Groundwater Remedy Phase 1 Construction, PG&E Topock Compressor Station, Needles, California

#### Work Variance Request #6 – Realignment of Pipeline F to Pipelines J and B

REVISED DRAWINGS FOR WORK VARIANCE REQUEST #6

C-07-107 REV 5

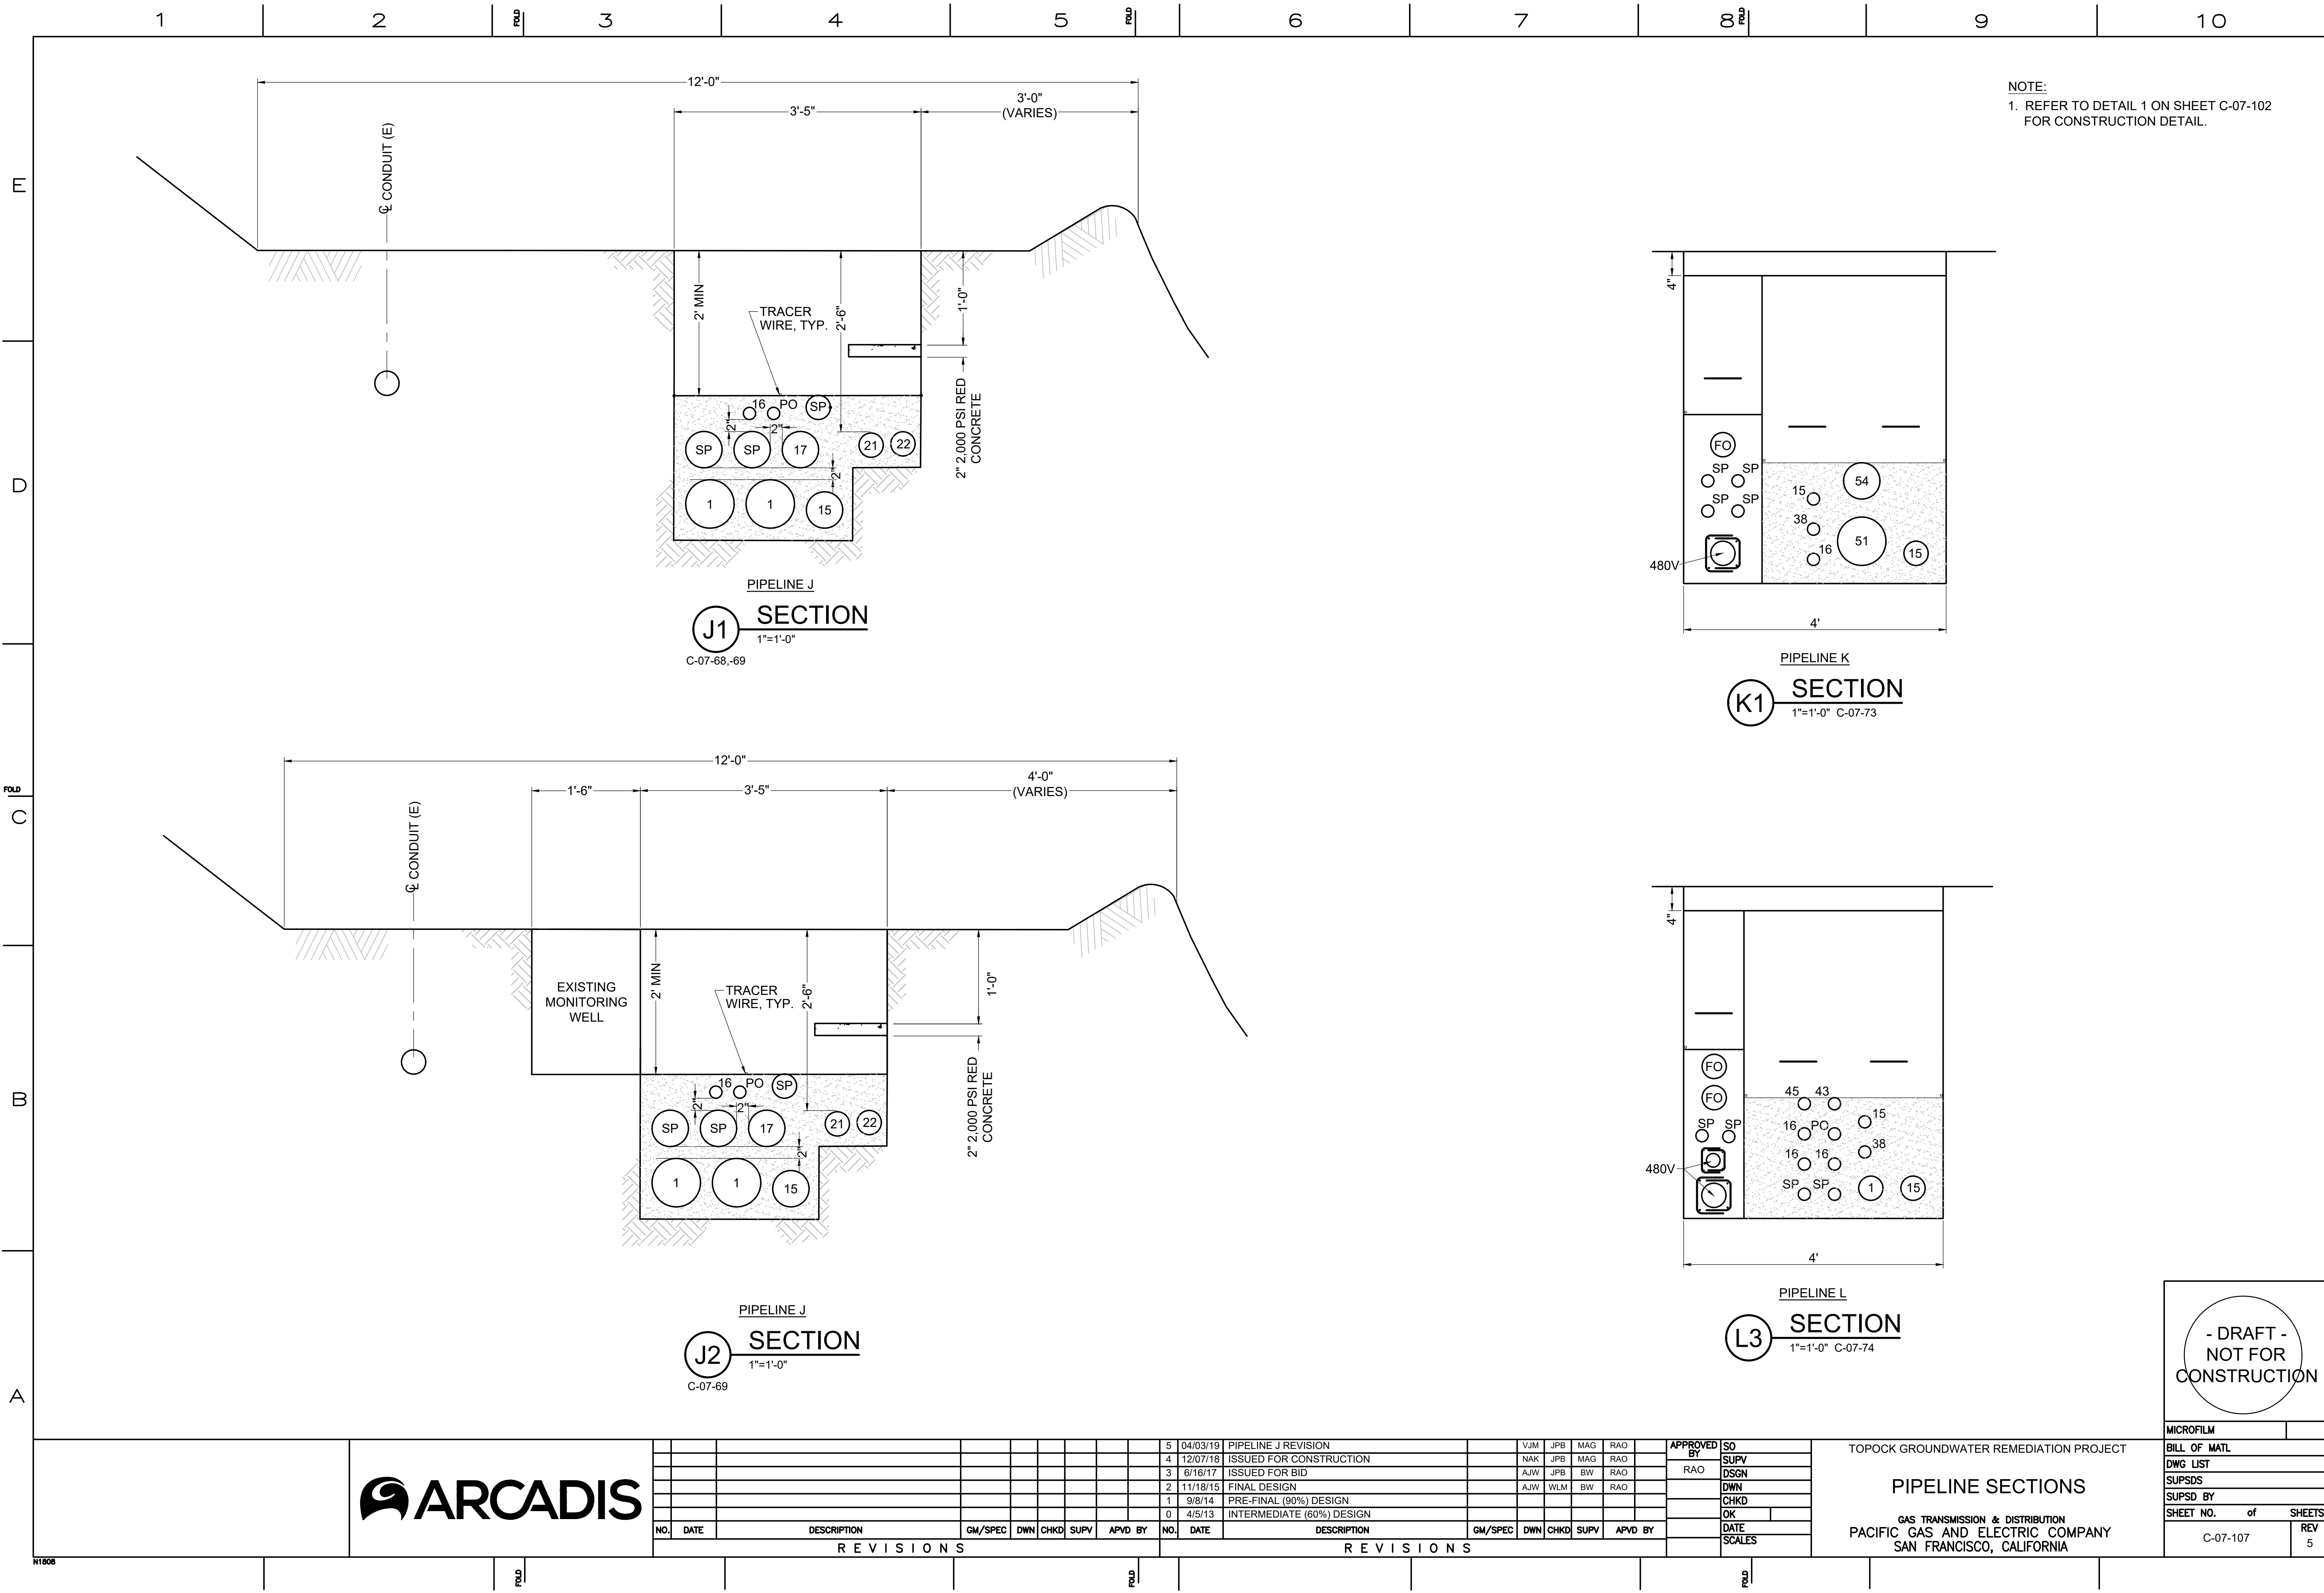
5	04/03/19	PIPELINE J REVISION		VJM	JPB	MAG	RAO		APPROVED BY	SO
										4	12/07/18	ISSUED FOR CONSTRUCTION		NAK	JPB	MAG	RAO		BY	SUPV
										3	6/16/17	ISSUED FOR BID		AJW	JPB	BW	RAO		RAO	DSGN
										2	11/18/15	FINAL DESIGN		AJW	WLM	BW	RAO			DWN
										1	9/8/14	PRE-FINAL (90%) DESIGN								CHKD
										0	4/5/13	INTERMEDIATE (60%) DESIGN								OK
																				DATE
																				SCALES
